EN 13445 "Unfired pressure vessels" Maintenance Help Desk (MHD) Question form

EN 13445 "Unfired pressure vessels" Maintenance Help Desk (MHD) Question form

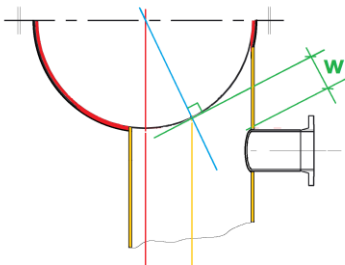
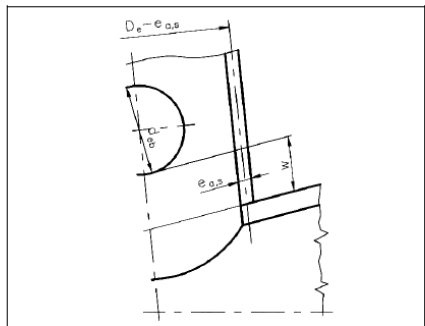
| <p>In EN13445-3 annex B the denomination "bounded variable action" is used without any definition, and has the partial factor $\gamma_Q=1,0$. Unbounded variable actions has $\gamma_Q=1,5$, acc. to table B.8-1. There is a need to clarify if it is in line with the overall safety of EN13445 to classify loading from pipe expansion on vessel nozzles as bounded variable action, and use $\gamma_Q=1,0$.</p> <p>In some other standards (Eurocode) "bounded actions" are used for a wide range of loads, such as wind load and snow load. This brings risk of misunderstanding EN13445. (In Eurocode all variable actions have a partial factor $\gamma_Q=1,5$).</p> <p>Question/comment: Which partial factor shall be applied on nozzle loads from piping, when performing a GPD analysis according to EN13445-3 Annex B?</p> <p>Proposed answer(s): * Loads from piping thermal expansion on vessel nozzles shall have partial safety factor of $\gamma_Q=1,5$, because there is no natural limit to the load.</p> | | | | | |

| The proposed answer is incorrect. Thermal expansion is normally bounded. It is the responsibility of the designer to determine whether the load is bounded or unbounded. WG 53 in charge of part 3 will try to find an explanation to help the user of the standard. | | | | | |
